SEWAGE DISPOSAL SYSTEM
DEPARTMENT OF HEALTH AND MENTAL HYGIENE

SUBDIVISION Wellington LOT 13 ROAD 2825 Hunt Valley Drive

**PLOT PLAN
WELLINGTON
SECTION 1, AREA 1**

LOT 13
PLAT NO. 8946
4th ELECTION DISTRICT
HOWARD COUNTY, MARYLAND

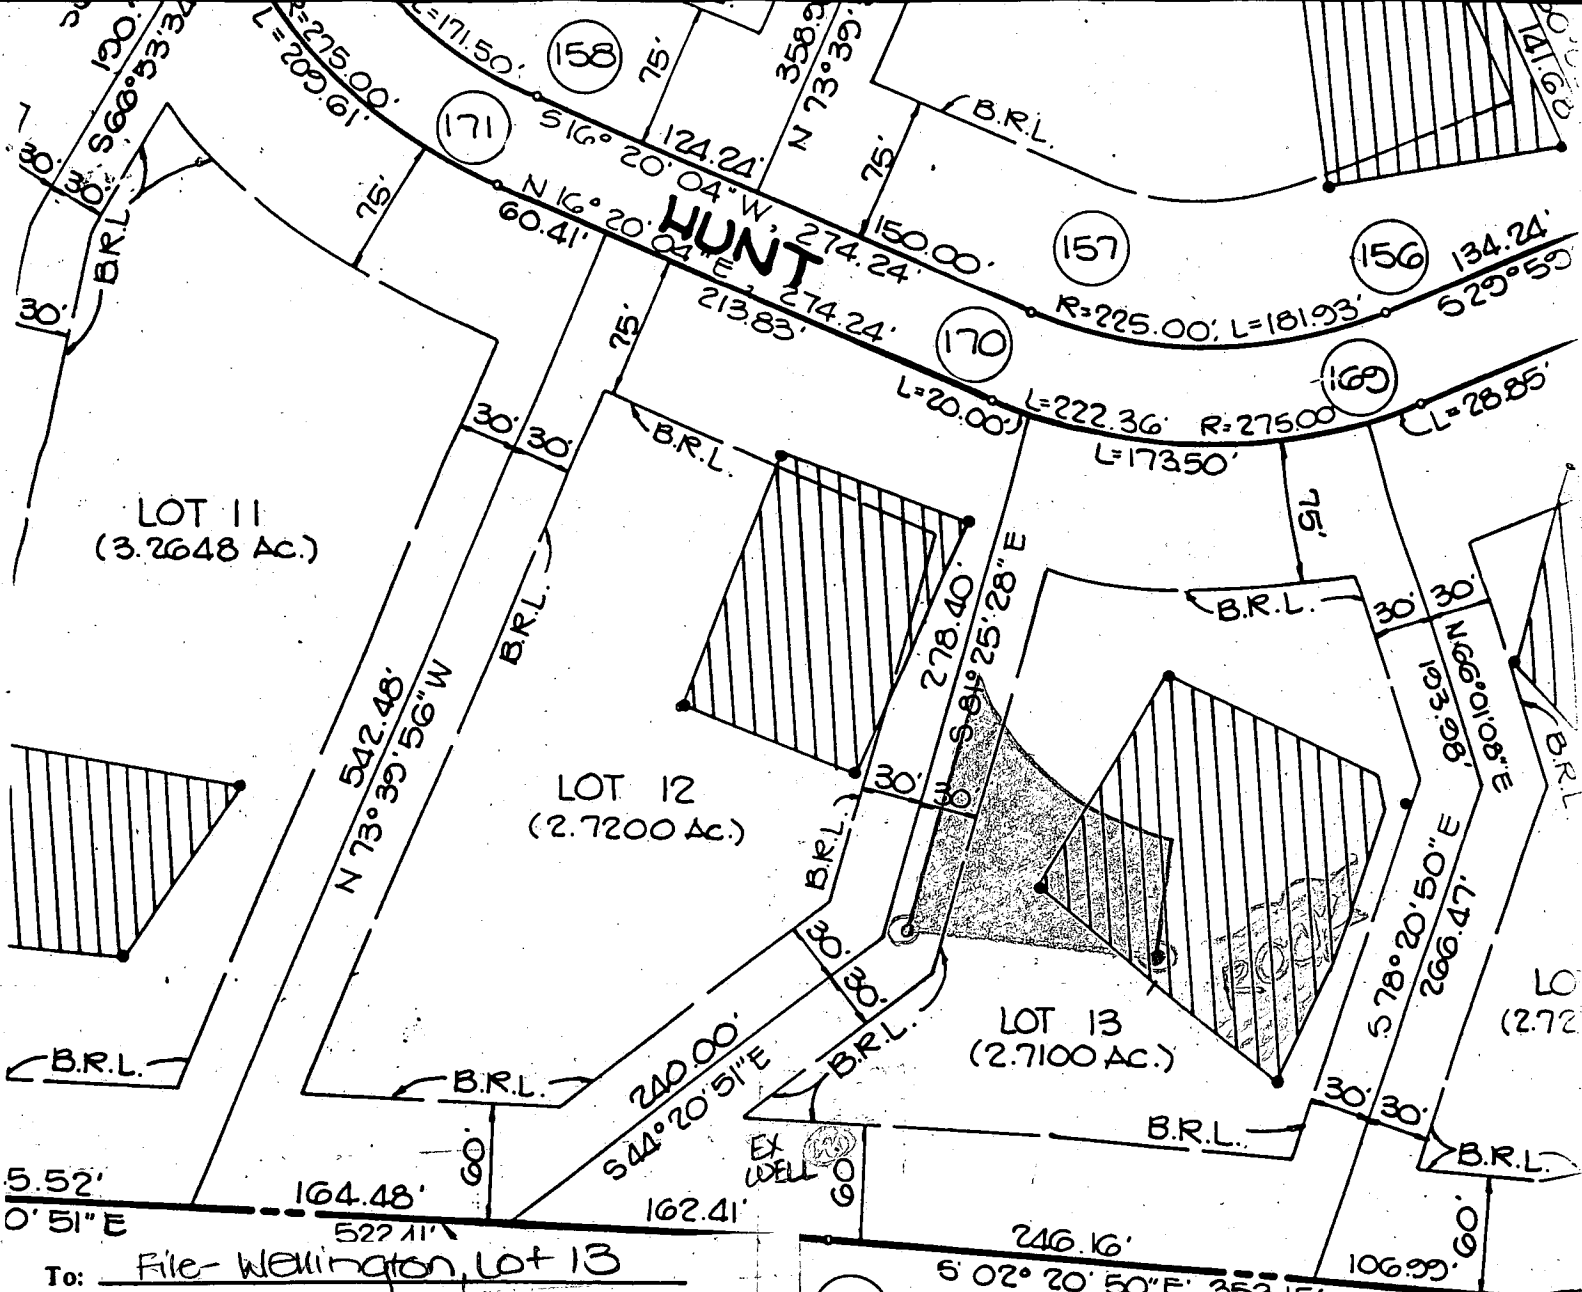
REMARKS: 8/13/97 A.M. layout check OK - location of dist. box changed. Location of play area confirmed.

OK to start system. DKS 8/15/97 excessive rock found at specified dist. box location. Perc area /dist. box location modified - OK to start trenches. DKS Trench OK to cover.

Shaded septic area replaces the originally approved septic area - excessive rock was found at several loc. w/in the original area. Perc holes to establish the new area were tested as indicated.

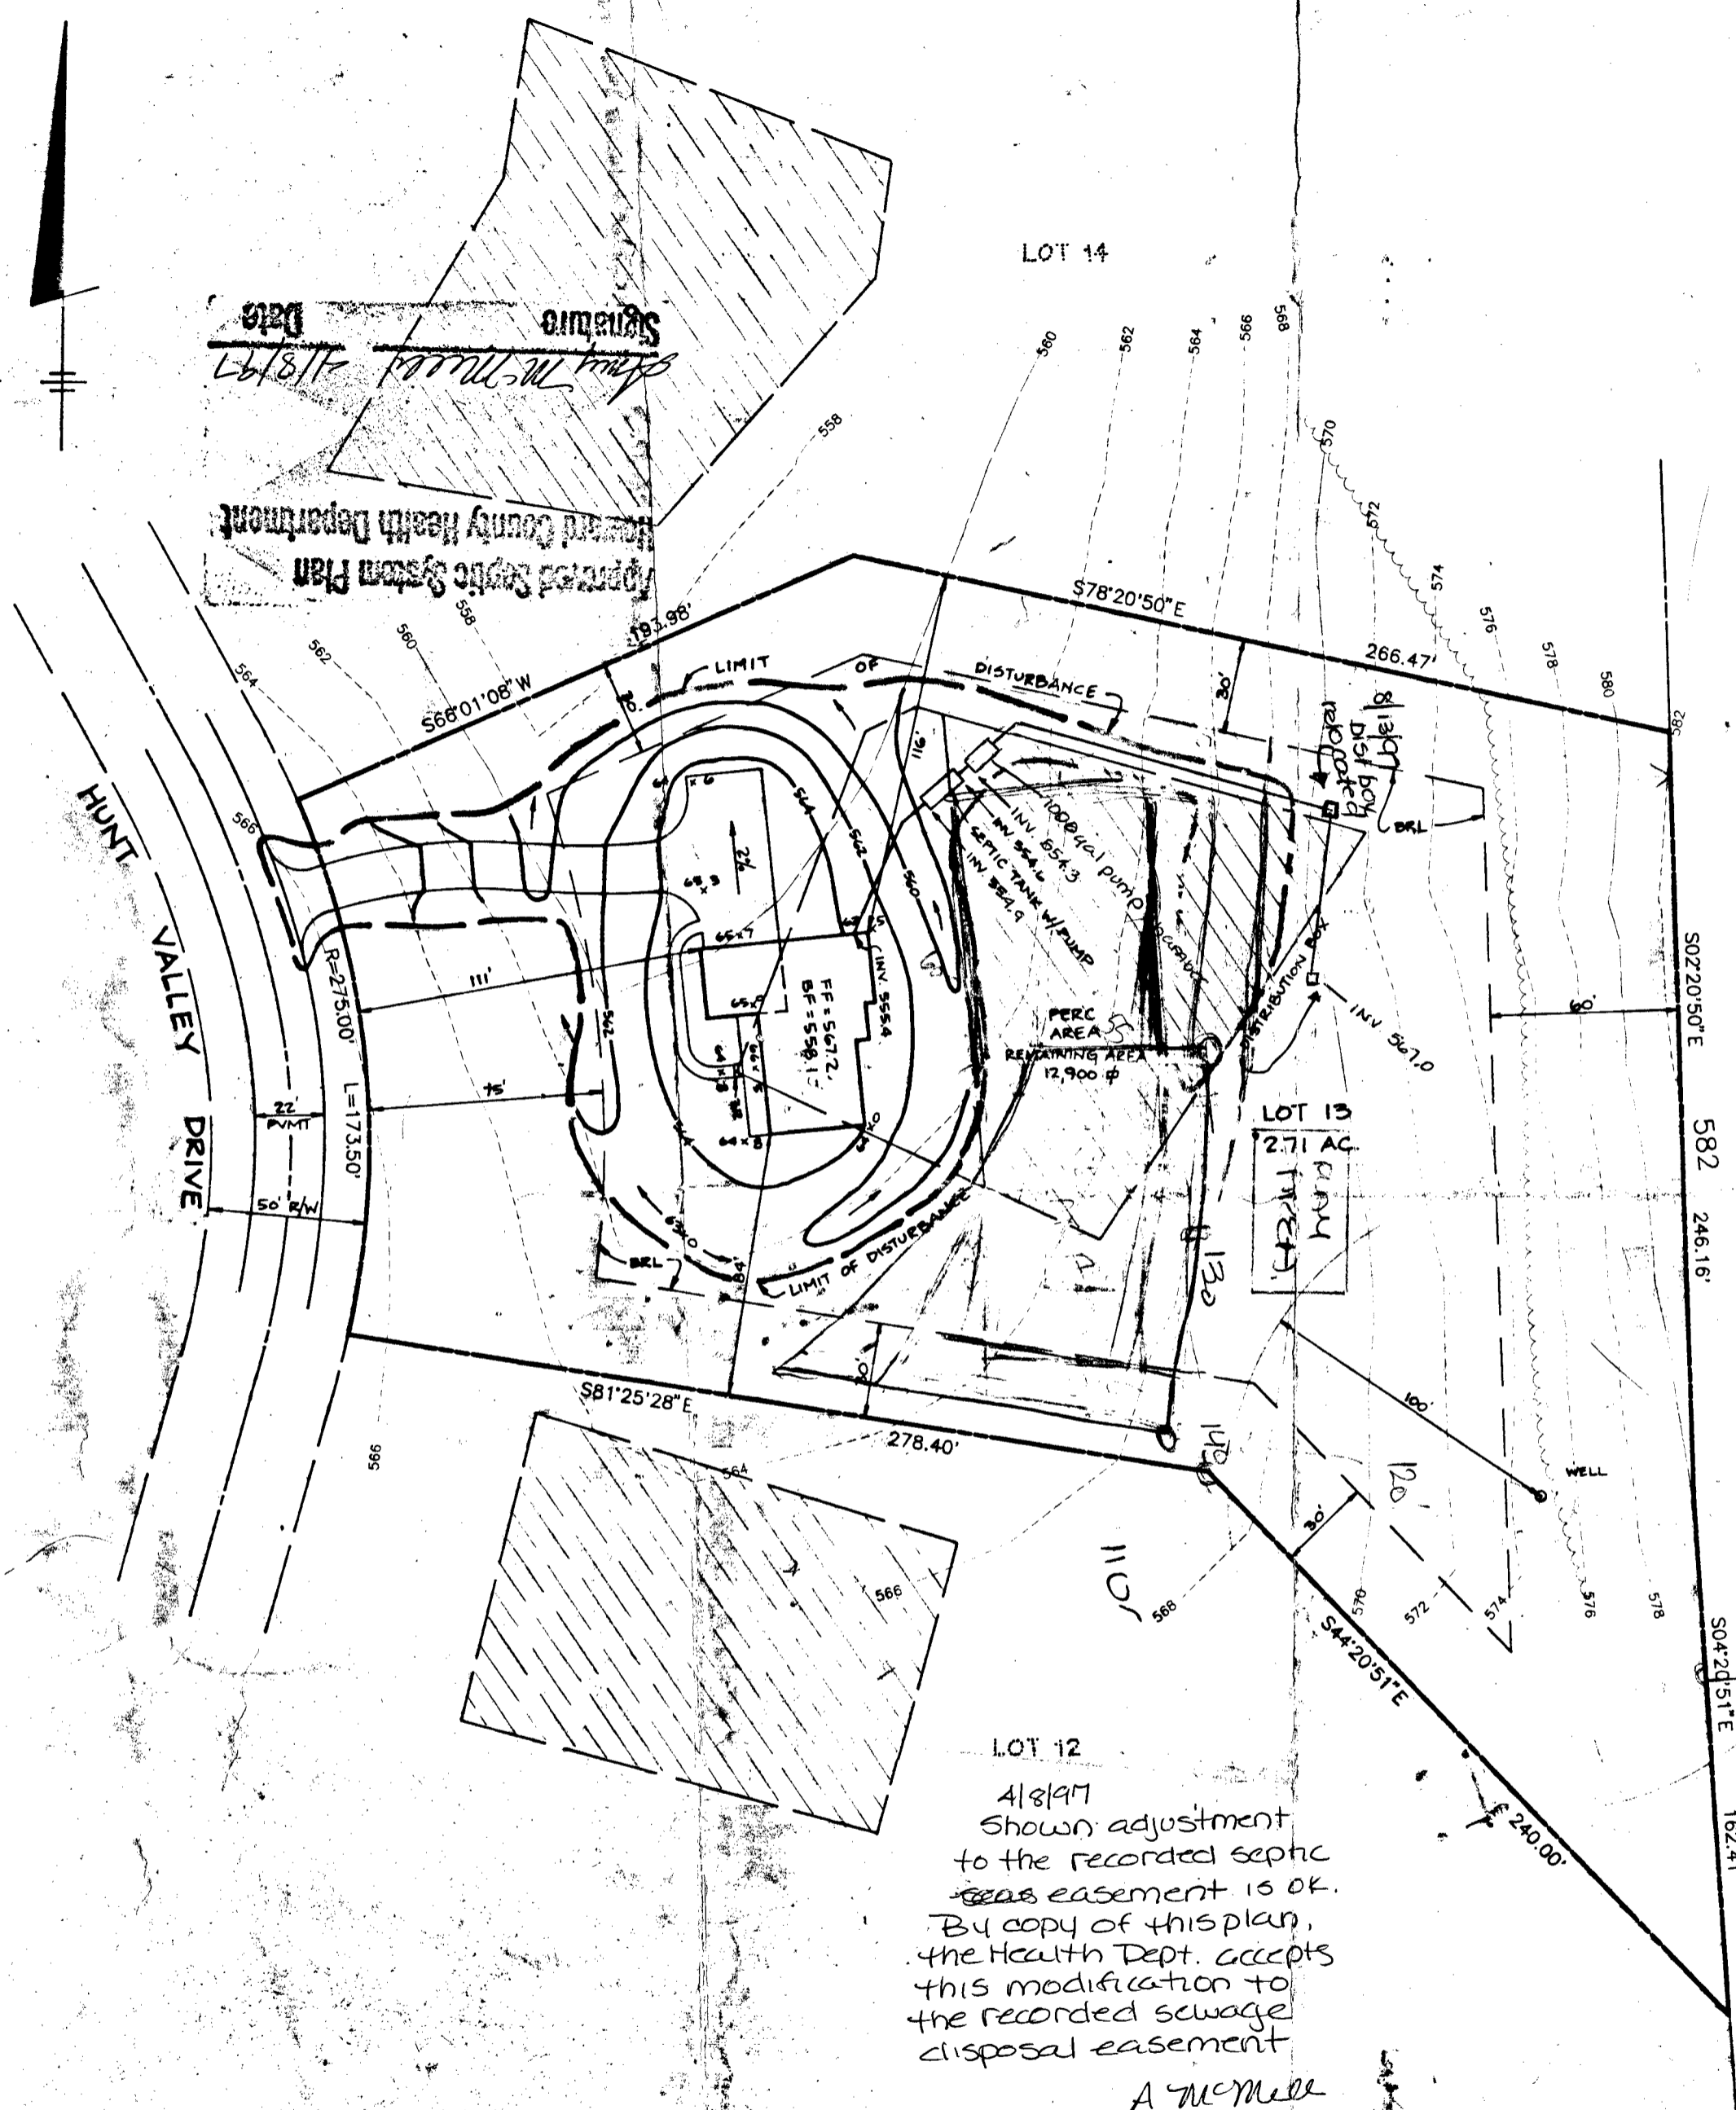
LOT 12
4/8/97
Shown adjustment
to the recorded septic
sewer easement is OK.
By copy of this plan,
the Health Dept. accepts
this modification to
the recorded sewage
disposal easement
A McMill
